CITY OF NORTH OAKS

Regular Planning Commission Meeting

7a. Public Hearing - Consider Conditional Use Permit for building height in excess of 35 feet for property located at 8 Sherwood Trail. Consider driveway setback variance.

PLANNING REPORT

OPTION 1

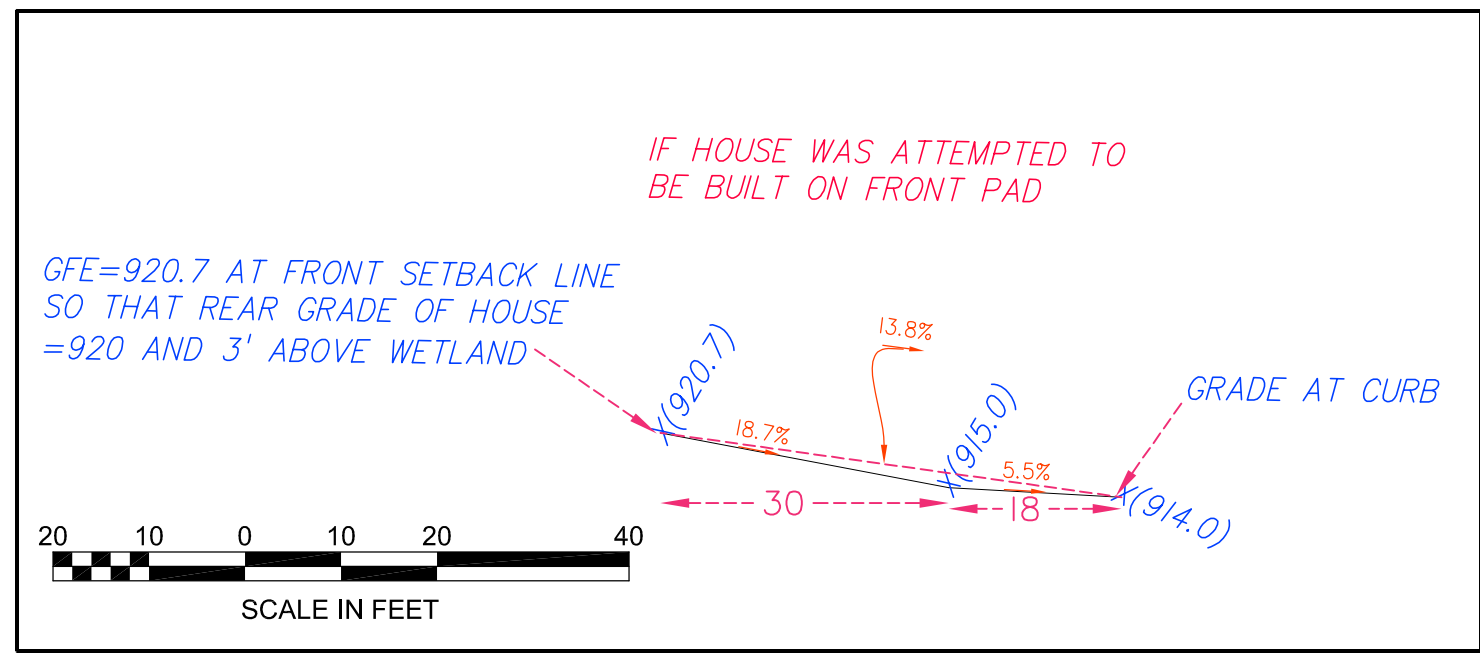
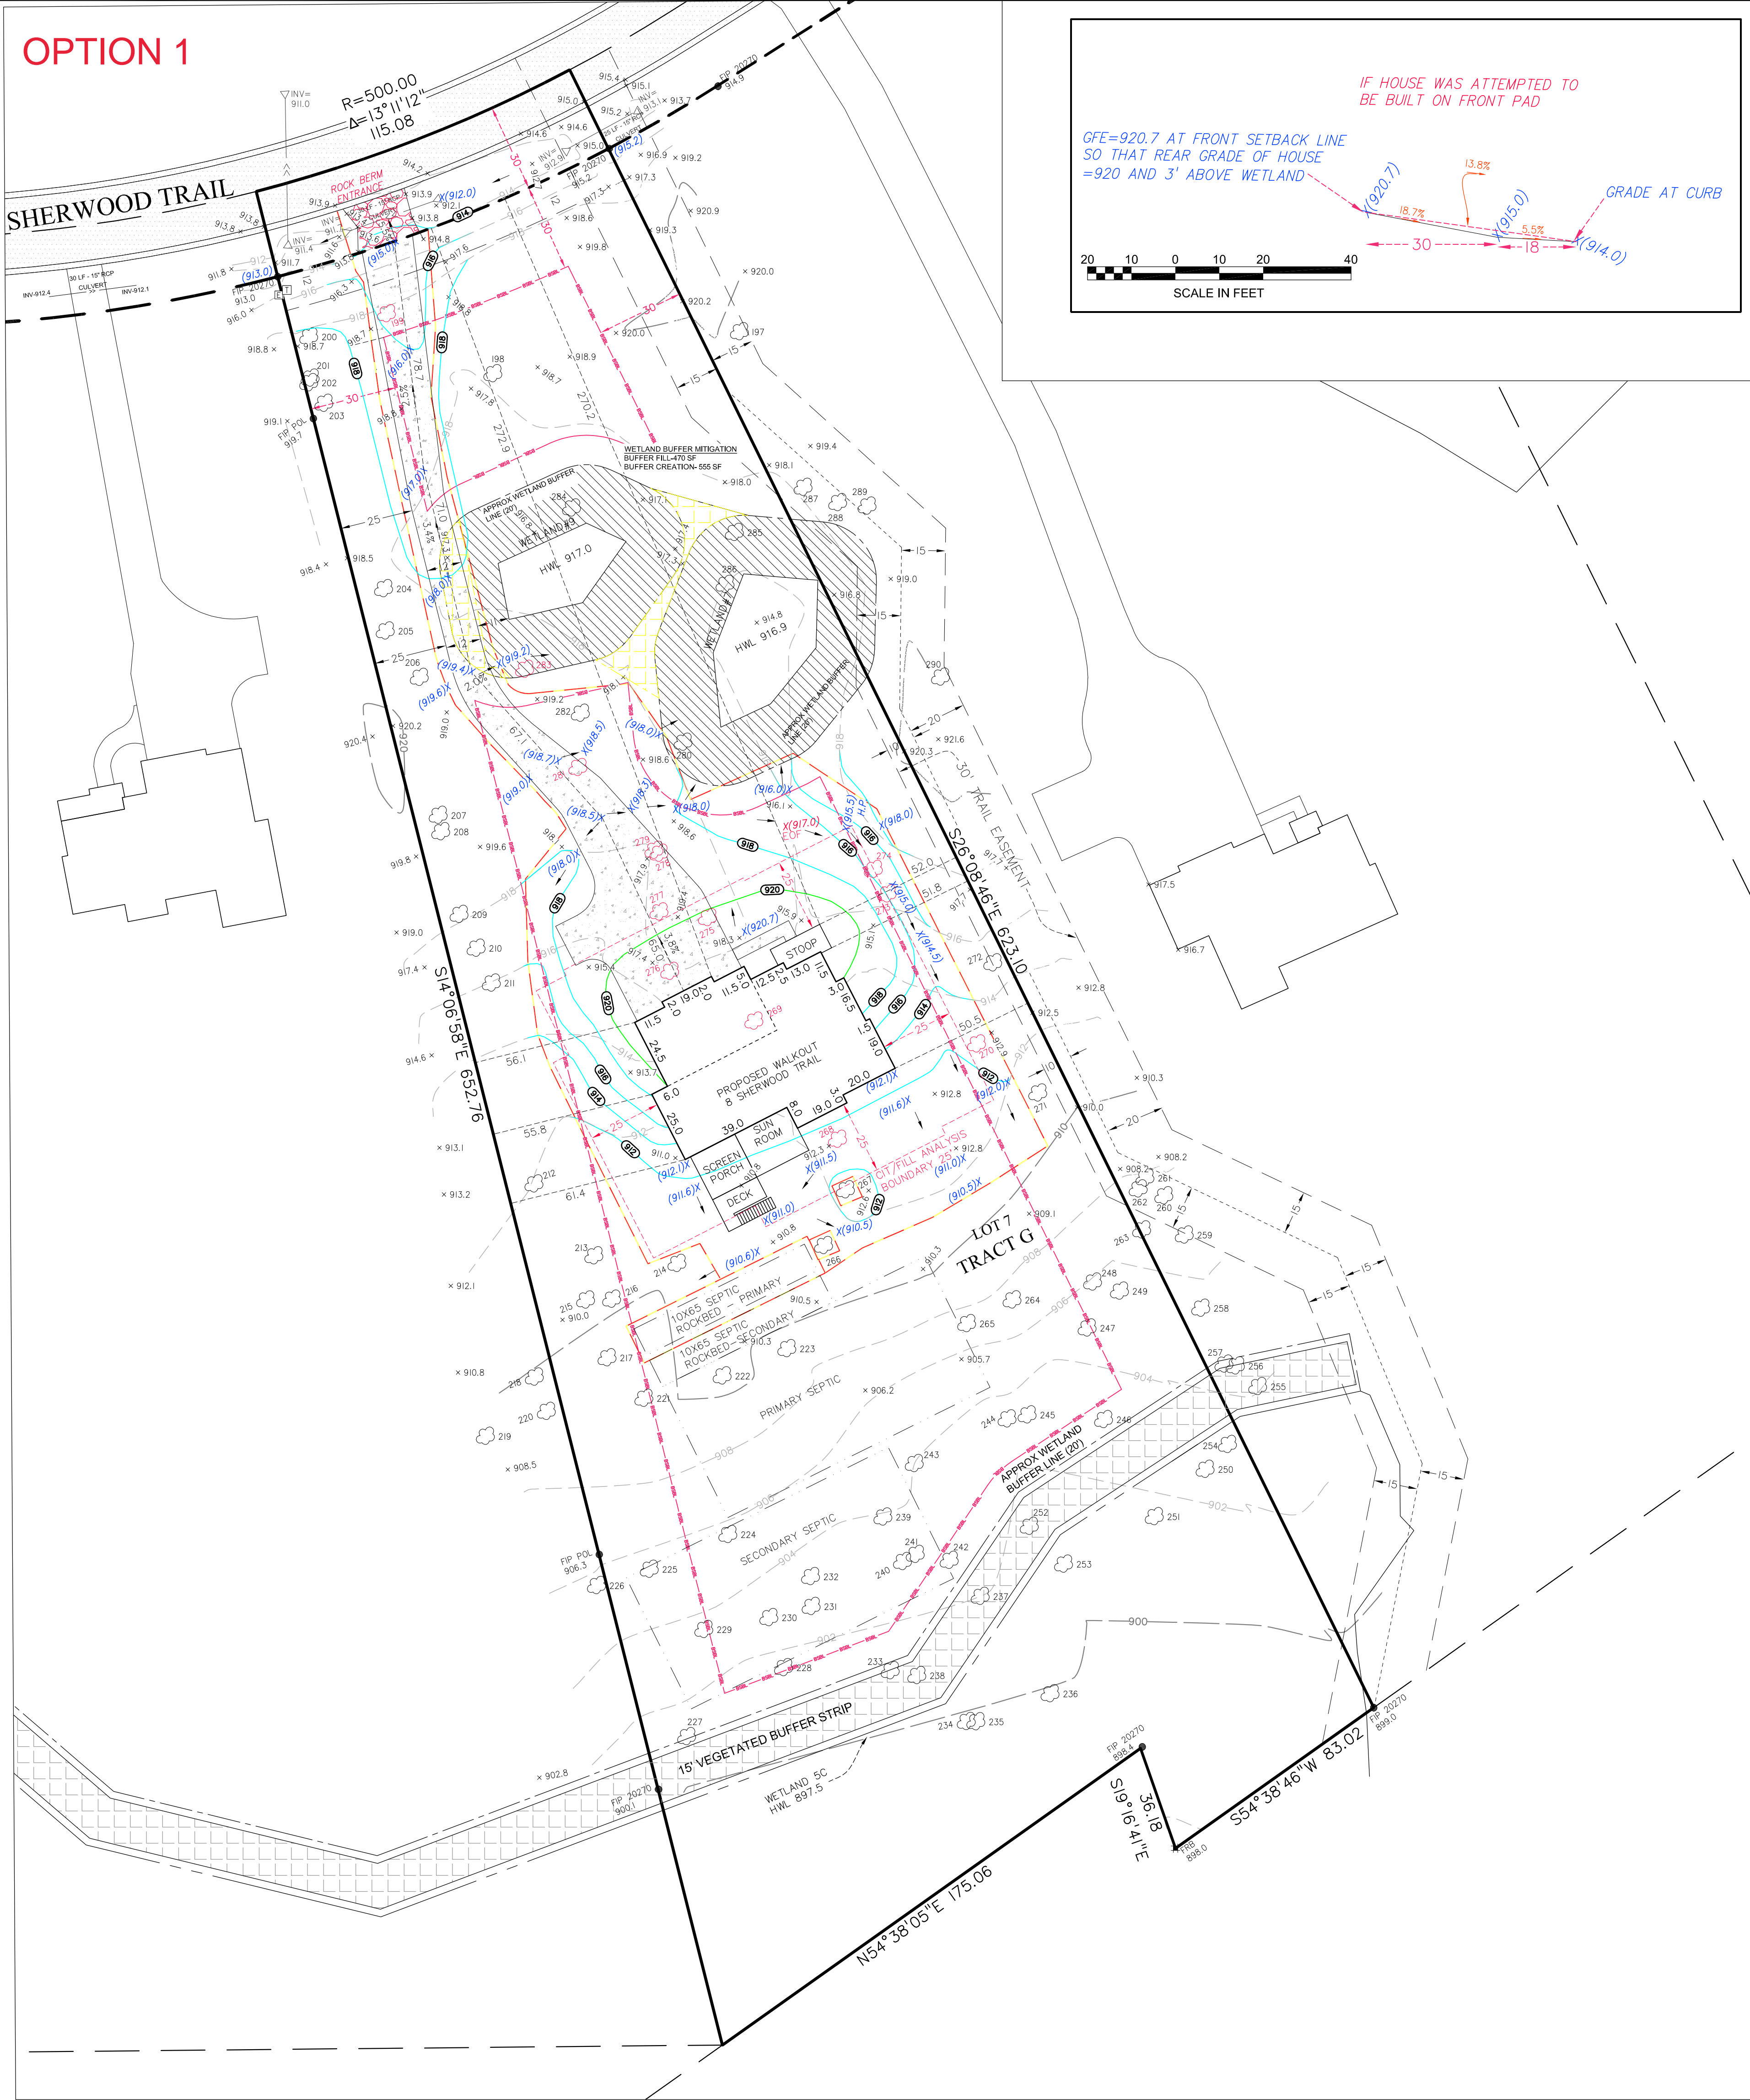
Option 1 requires less of a variance when the setback variation from the required side yard setback and wetland setback is evaluated but it impacts more sq. ft. of buffer than Option 2 according to the applicant's plan.

The Commission could find there is no practical difficulty and the landowner simply needs to develop a home plan that fits the lot without the need for a variance. The final plans/plat for Red Forest Way South Phase 1 showed the house pad on the front of the lot. The approvals for the subdivision were based on the approved plans and due diligence as part of the land purchase should have identified this home site. The City Code prohibits the creation of parcels that are unbuildable and the developer showed a driveway and home site that they deemed buildable when the lot was created.

However, the Commission could find that the approved plans showed the home site on the front of the lot and a home could be built there but would require a steep driveway grade and/or a smaller house than others in the neighborhood. The City of North Oaks has many lots with wetlands and this is not a unique circumstance.

Alternatively, the Commission could find that the variance is not the minimum action necessary as the driveway width could be reduced from 12 feet to 10 feet to reduce the variance. The Commission could find that there is no practical difficulty because the building pad site as approved can be developed but simply requires the builder to develop a smaller house plan that works with the existing site.

The Commission asked for two options from the applicant. Staff finds that Option 1 (with the driveway reduced to 10 feet at the wetland) results in the minimum amount of variance to allow a home to be constructed on the rear portion of the lot. If the Commission finds that the variance standards have been met for Option 1, staff recommends the following conditions of approval:

1. The driveway must be reduced from 12 feet to 10 feet wide at the narrowest point to minimize the wetland impact. This will increase the wetland buffer from 11 to 13 feet wide in that location.
2. Wetland buffer averaging must be used as shown on the plans.
3. Wetland buffer signs must be installed at the edge of the wetland buffer to protect the buffer. Buffer signs should be planted where needed to indicate the contour of the buffer, with a maximum spacing of 200 feet of wetland edge. The signs and sign plan must be submitted to City staff for review and approval.
4. Wetland buffer plantings must be installed to ensure quality vegetation to maximize the buffer benefits. A wetland buffer planting plan must be submitted to City staff for review and approval.

OPTION 2

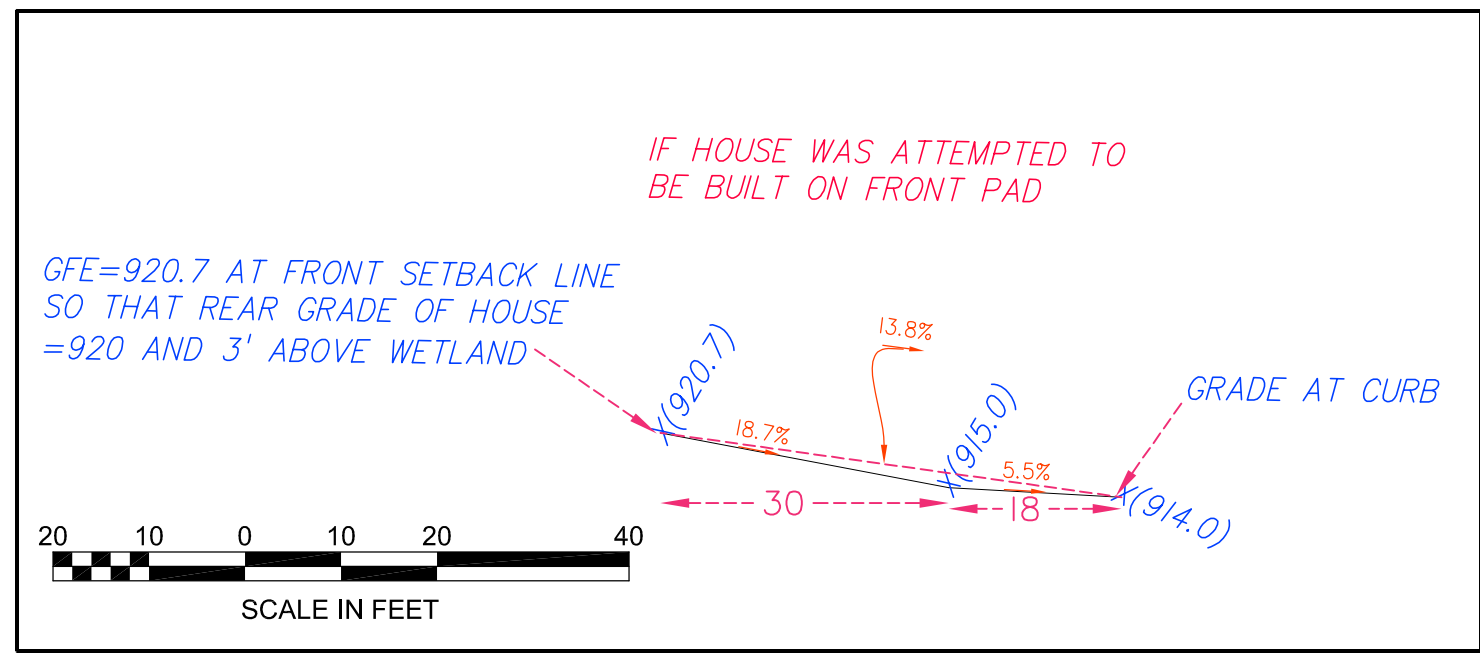
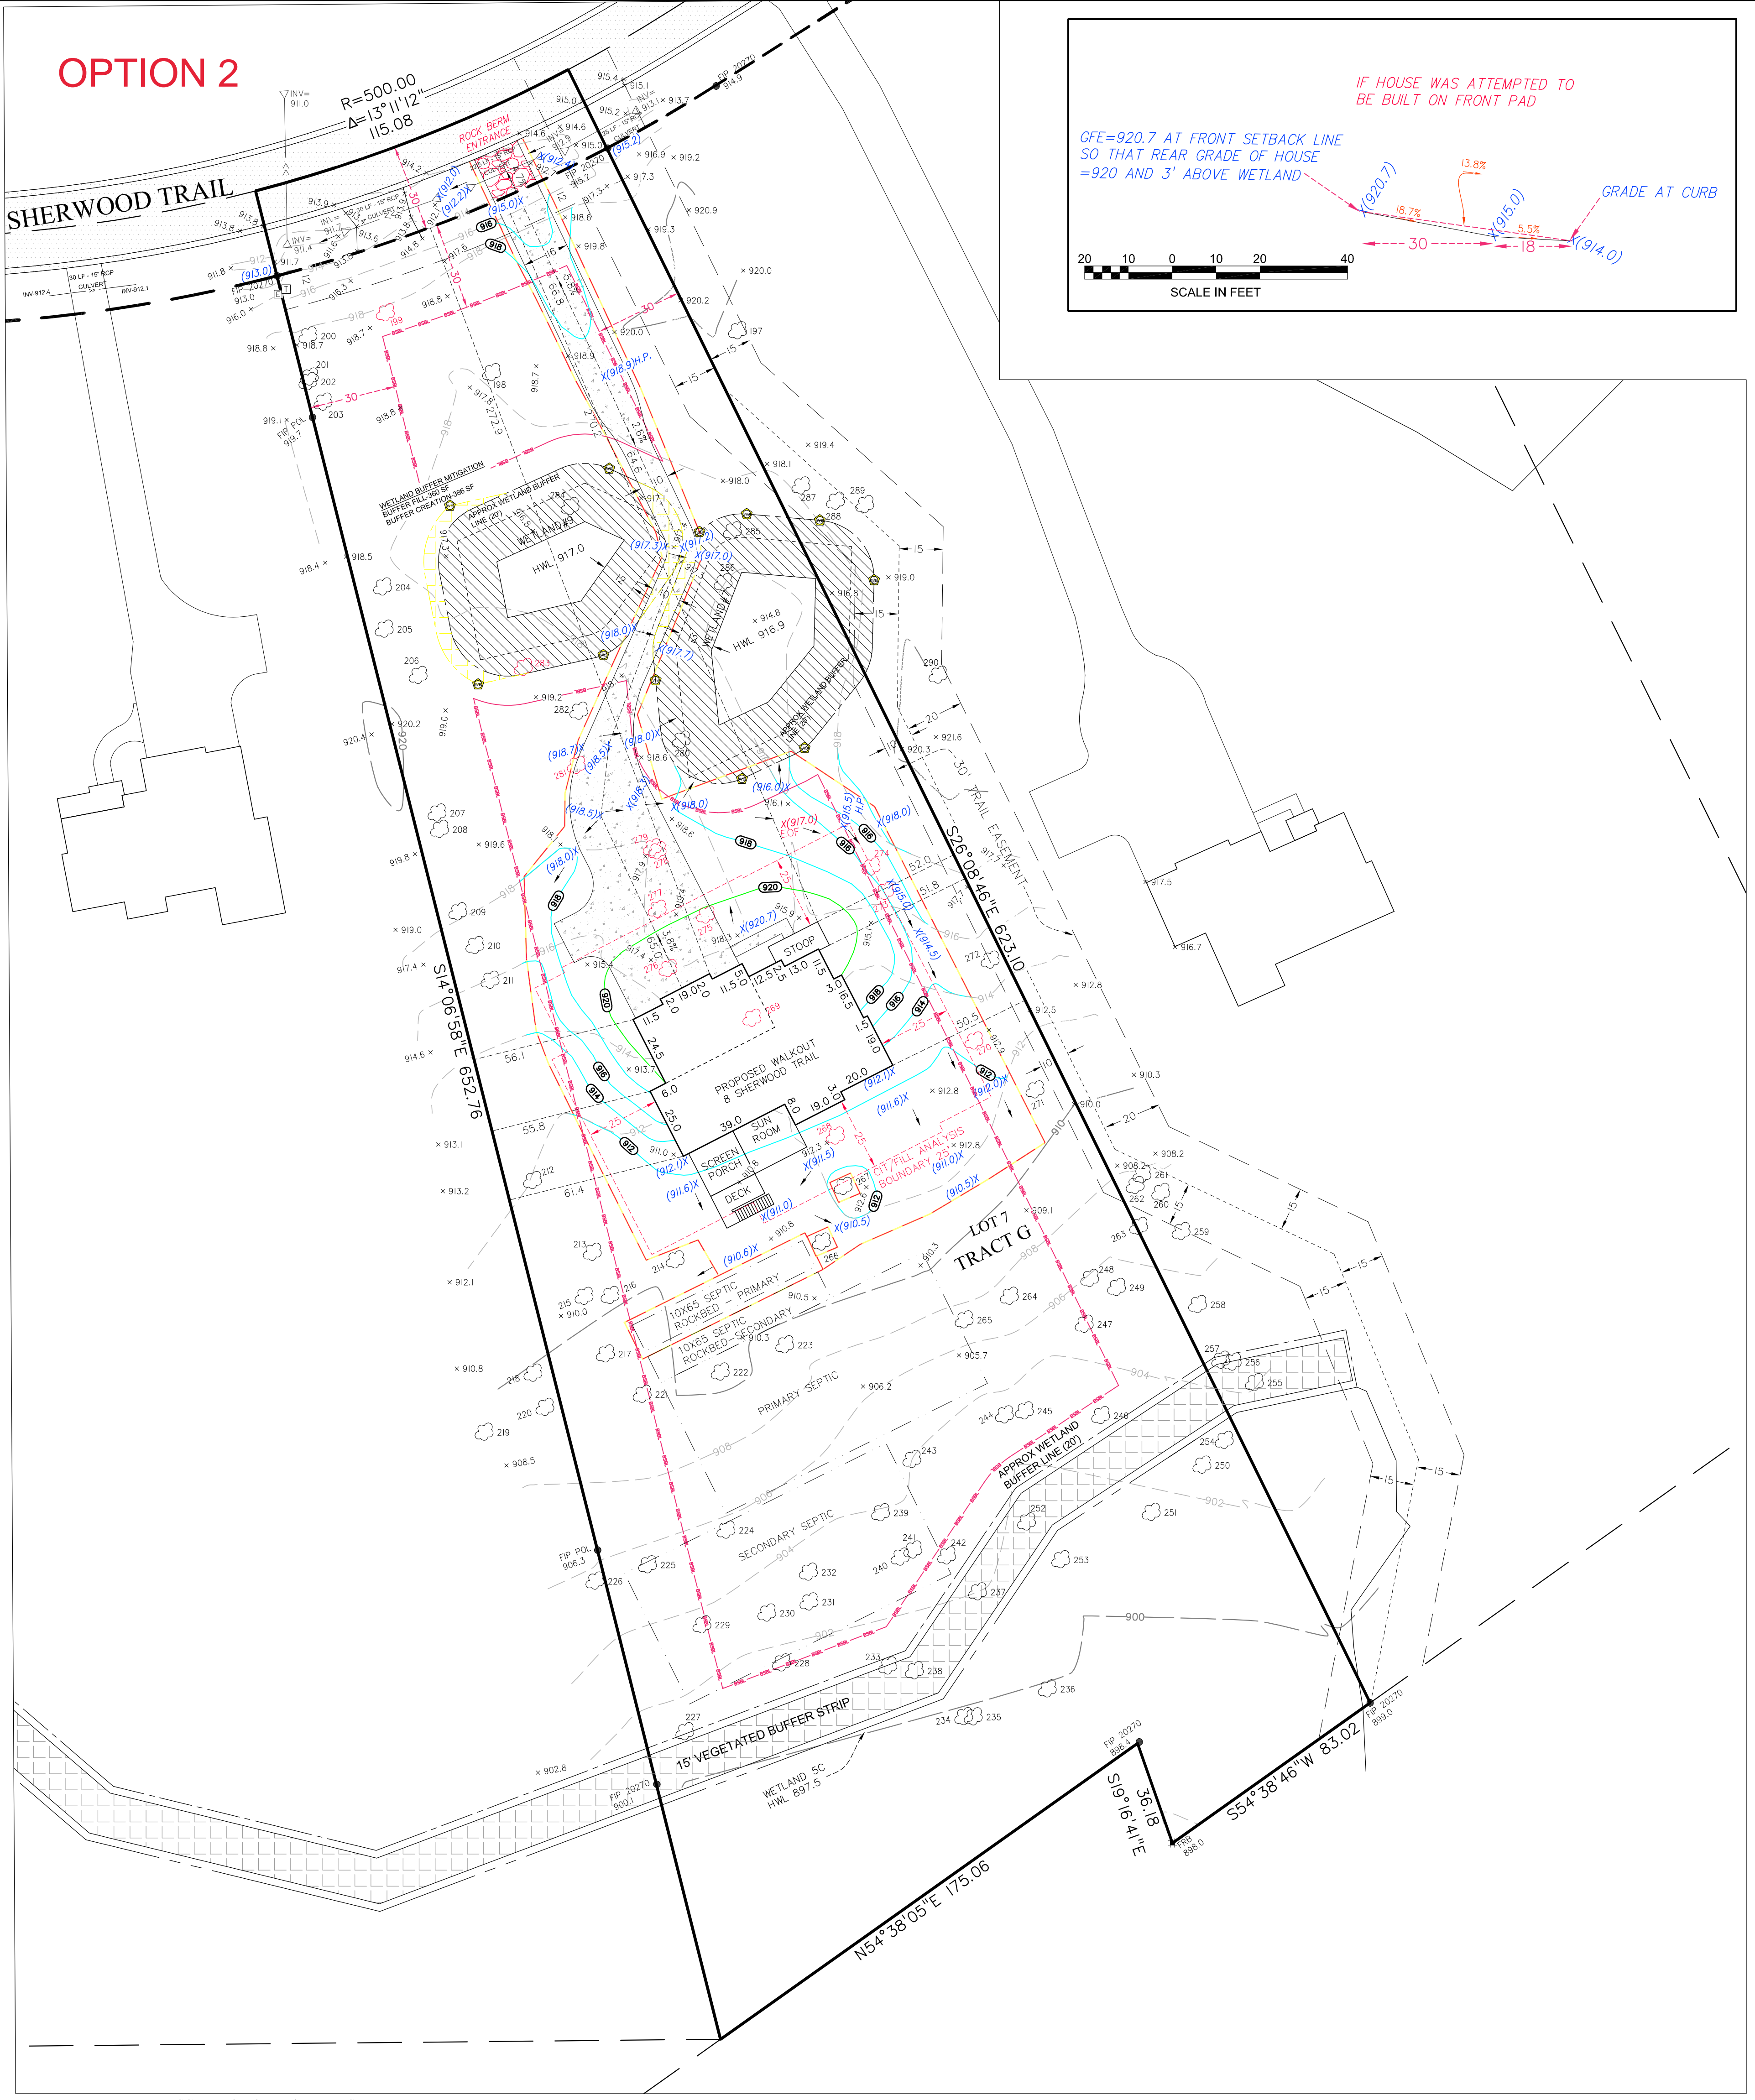
The Commission could find there is no practical difficulty and the landowner simply needs to develop a home plan that fits the lot without the need for a variance. The final plans/plat for Red Forest Way South Phase 1 showed the house pad on the front of the lot. The approvals for the subdivision were based on the approved plans and due diligence as part of the land purchase should have identified this home site. The City Code prohibits the creation of parcels that are unbuildable and the developer showed a driveway and home site that they deemed buildable when the lot was created. Furthermore, there is an alternative (Option 1) with less of a variance required.

The Planning Commission must evaluate whether or not the original building pad proposed by The North Oaks Company and approved by the City is a reasonable location or whether the location is not feasible and creates a practical difficulty. The Commission could agree with Hanson Builders that the house they designed does not fit on this lot, but find that is not a practical difficulty, because a different home could be designed to work with the site conditions and not require a variance. The Commission could find that while not ideal, a driveway with a grade in excess of 10% could be constructed and such driveways do exist in the region. Or the Commission could find that a driveway could be located in a different location with less of a variance required.

However, the Commission could find that the approved plans showed the home site on the front of the lot and a home could be built there but would require a steep driveway grade and/or a smaller house than others in the neighborhood. The City of North Oaks has many lots with wetlands and this is not a unique circumstance. The Commission could also find that the landowner has options for a driveway that would result in less of a variance.

The Commission could find that there is no practical difficulty because the building pad site as approved can be developed but simply requires the builder to develop a smaller house plan that works with the existing site. The Commission could also find that a driveway variance is required but the driveway could be moved to the west and result in less of a variance.
